**PLANS AND DOCUMENTS
referred to in the PDA
DEVELOPMENT APPROVAL**

Approval no: DEV2018/961

Subject: Addendum to the bushfire management plan for the proposed development at 4499-4651 Mount Lindsay Highway, North Maclean

LEC Land and environment consultants	Client Wearco Pty Ltd	Project 4499-4651 Mt Lindsay Highway Bushfire Management Plan	Figure 1	
			Title Bushfire Addendum	
			Design 14.02.2019 Drawn 14.02.2019 Scale 1:7500 Cad File 108 North Maclean02.dwg Rev 1.0

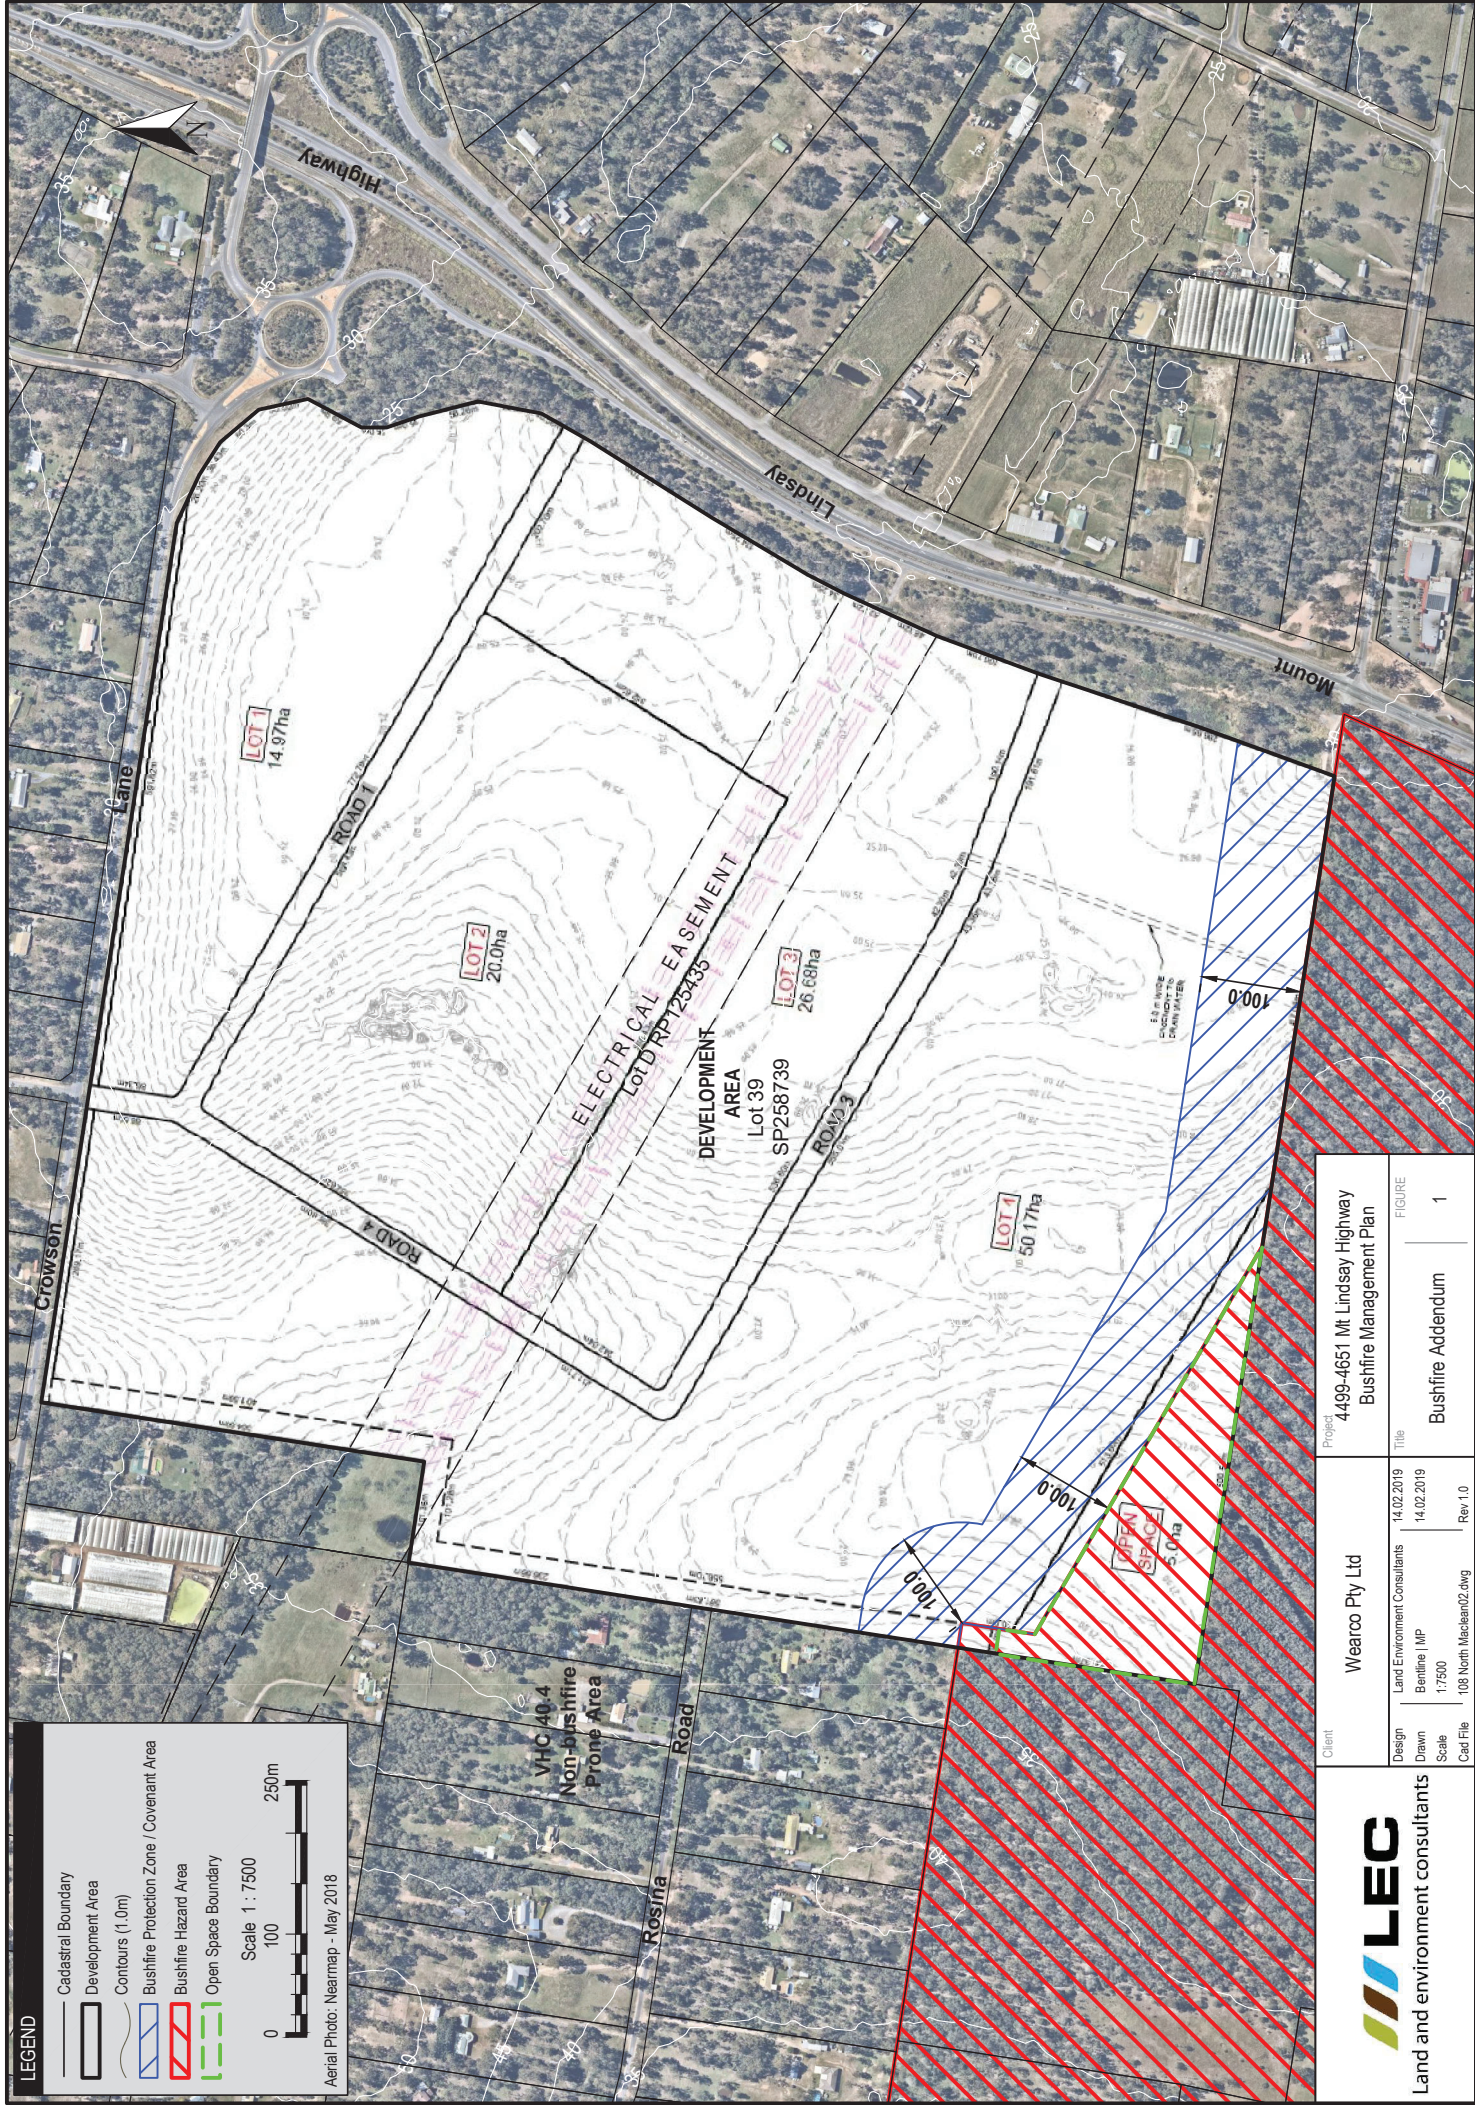
The BMP shows that the land to the west of the site is located within the 'Medium Potential Bushfire Intensity' Bushfire Hazard Area (Figure 2.1). Section 3.5 of the BMP states the SPP bushfire hazard assessment manual identifies land within 100 m of high and medium bushfire hazard areas as a potential impact buffer. It is noted that not all the land on the western boundary where it adjoins Medium Potential Bushfire Intensity' Bushfire Hazard Area provides for a bushfire buffer area. Provide clarification on the extent of the bushfire buffer along the western boundary noting the above.

Figure 1 provides clarification on the location of medium and high potential bushfire intensity areas in relation to the boundary of the site. It shows high and medium potential bushfire intensity areas occur adjacent the south boundary of the site and the southern part of the western boundary of the site.

The 100 m wide potential impact buffer to the medium and high potential bushfire intensity areas is shown on Figure 1 and is identified as a 'bushfire protection zone'. Section 6.1 in the BMP identifies the development effects of the bushfire protection zone on the developer and prospective purchasers of the affected lot.
